What we heard report

Stage 1 public consultation: Draft Lachlan Valley Floodplain Management Plan

September 2026

Figure 12: Refinements made to the proposed floodway network near Kiacatoo

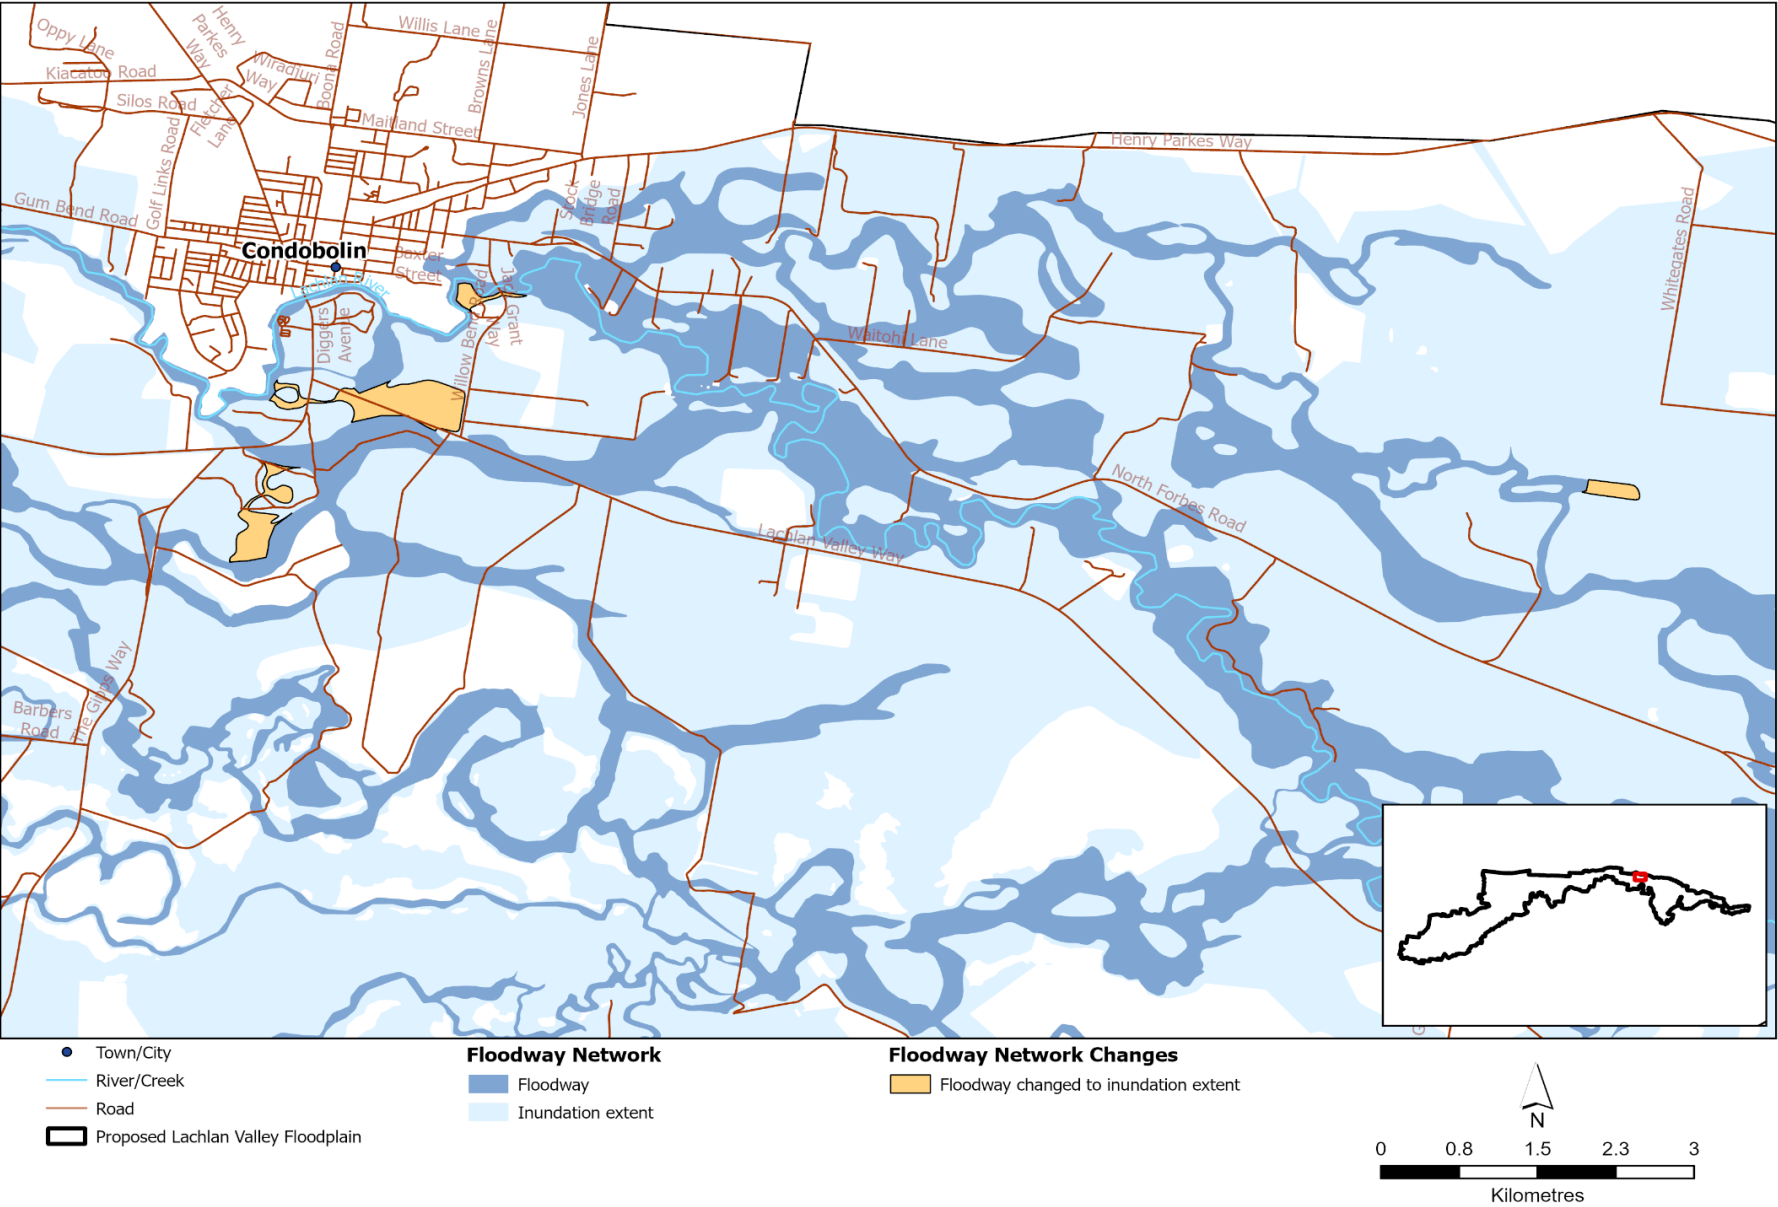
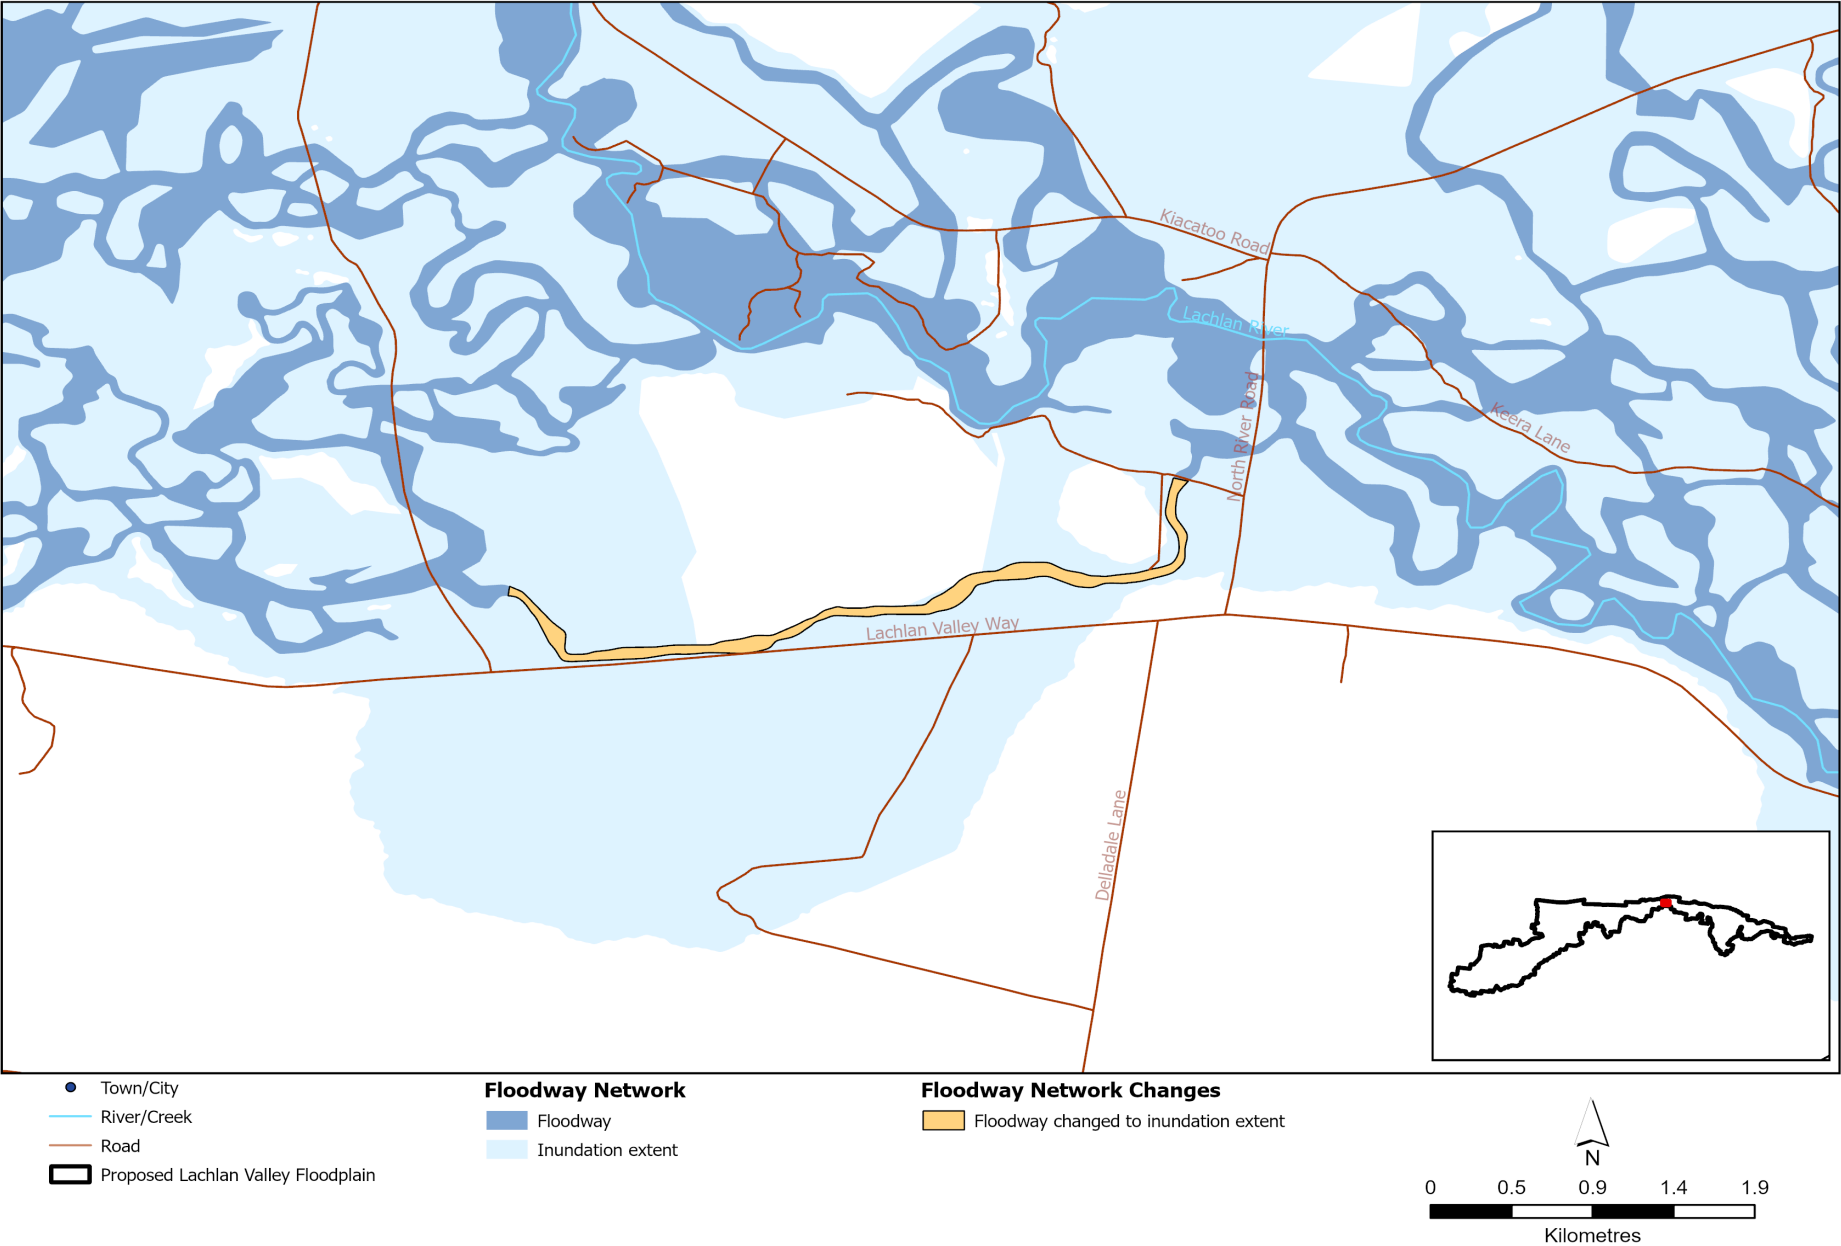
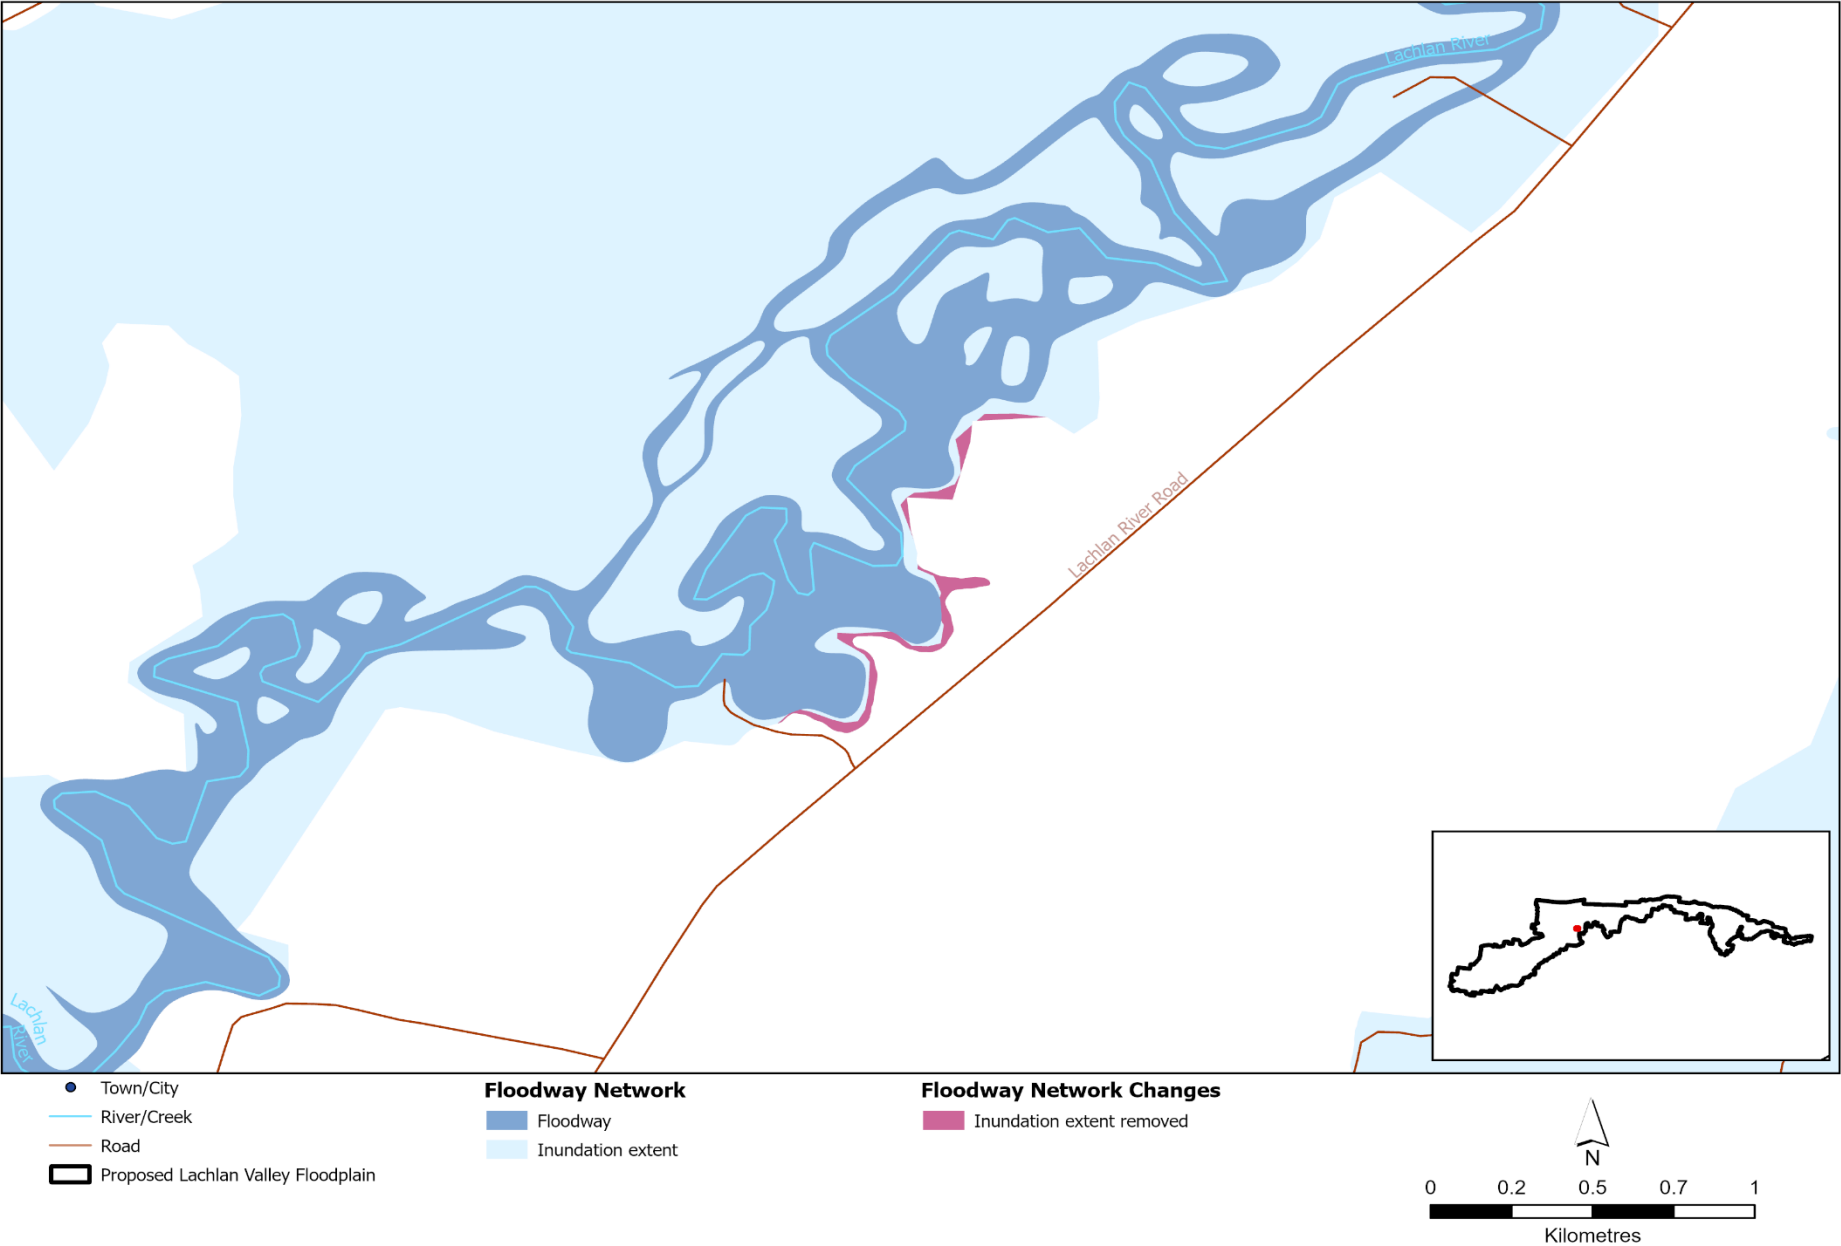
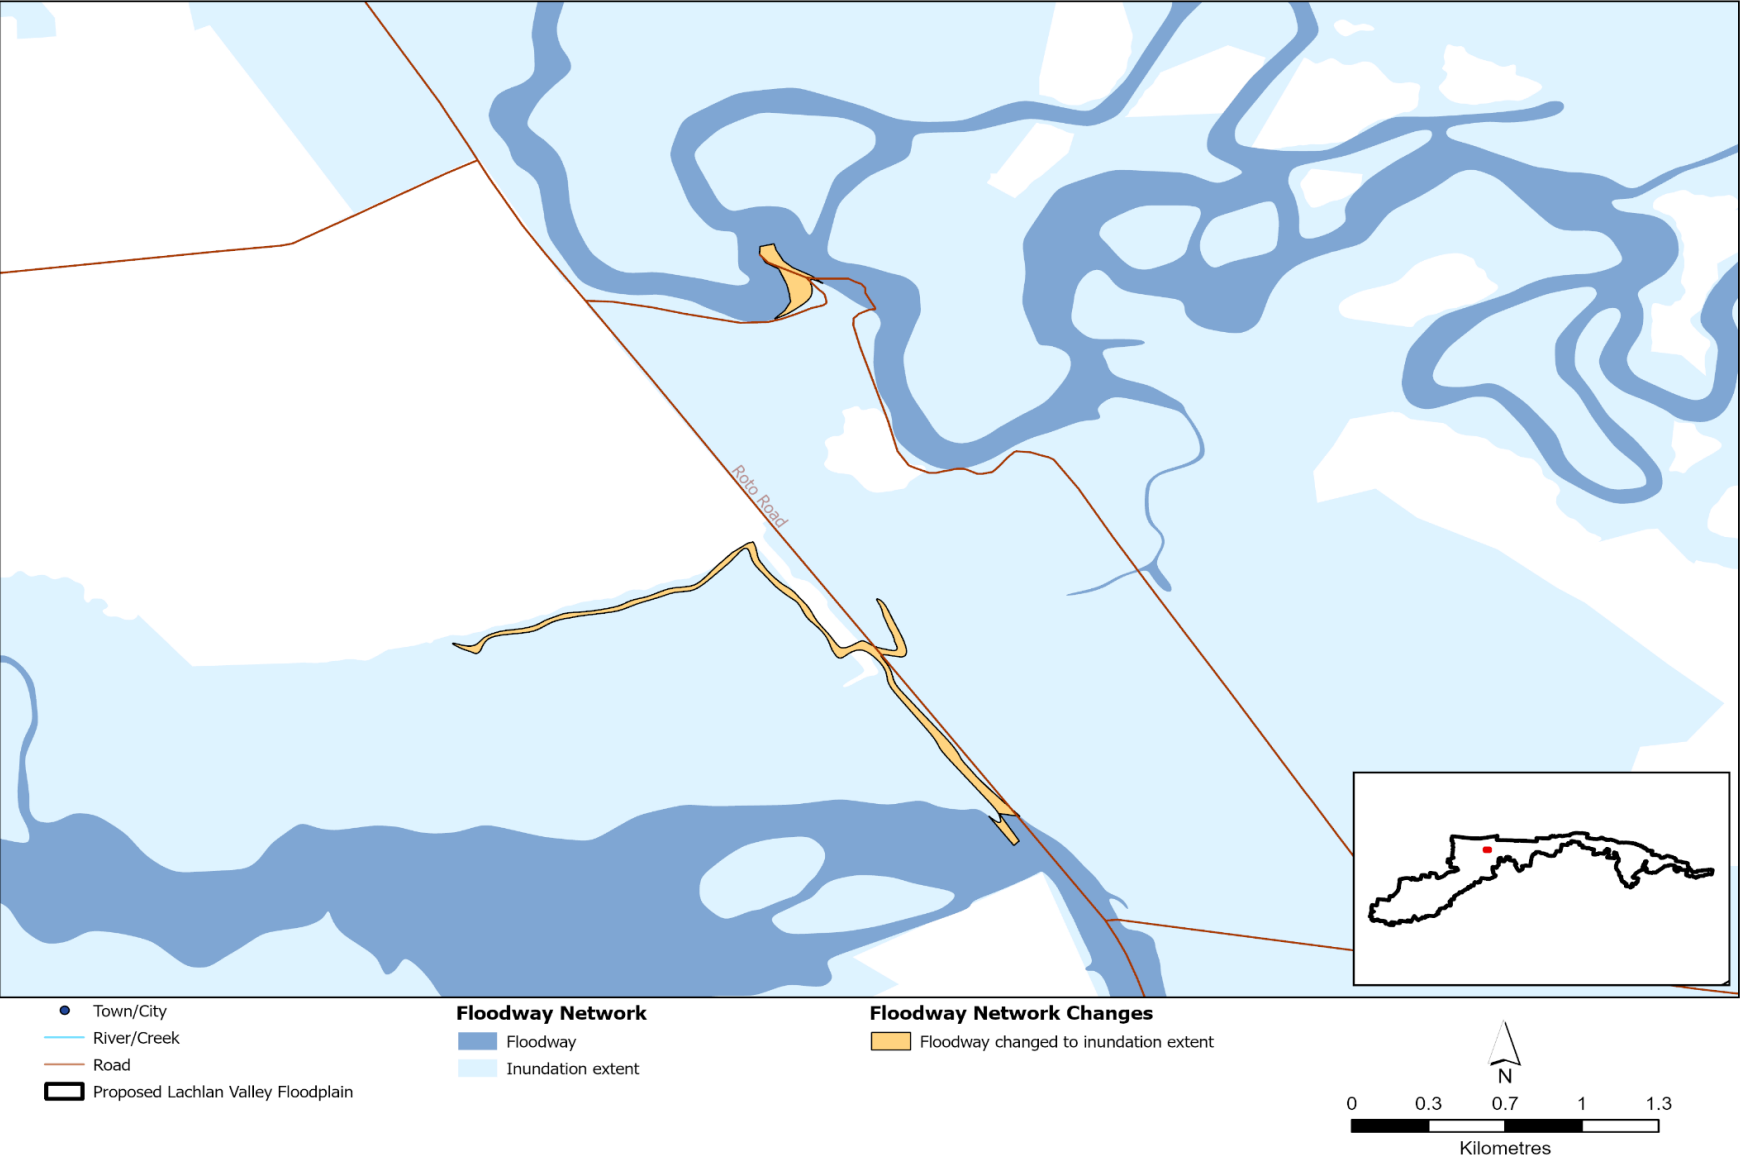
Feedback	Departmental response
Missing floodways from previous plans. There are several foodways that are completely missing from the draft plan, for example Greens Creek downstream of Forbes, and upstream from Jemalong gap.	In response to feedback, we updated the hydraulic model to better reflect the historical FMPs. Spatial refinements that resulted from this model update are shown in Figures 3 to 14 in Appendix 2.
The proposed floodway boundary near Lake Cowal is significantly narrower than the existing floodway. In our view, this may reduce the floodway's ability to convey and redistribute flood flows, increasing the risk of flood impacts and infrastructure failure.	See response above.
Local observations and on-ground validation should be used to validate, refine, and finalise modelling outputs.	Agree. Modelling outputs are validated using satellite imagery, surveying results, LiDAR and topographical information. Further, site-specific information and local flood knowledge provided through consultation, including information relating to flood behaviour, historical inundation and floodplain infrastructure in the identified areas, is considered during ongoing refinement of the proposed floodplain boundary and associated mapping.

We should follow the same guidelines that were used to approve flood works in past floodplain management plans to avoid operational changes and cost blowouts to landholders and communities.	See response above. In response to feedback, we updated the hydraulic model to better reflect the historical FMPs. The spatial refinements that resulted from this model update are shown in Figures 3 to 14 in Appendix 2.

Figures 3 to 14 provide an overview of refinements to the proposed floodway network in response to stakeholder feedback and updates to the hydraulic model to better reflect the historical FMPs.
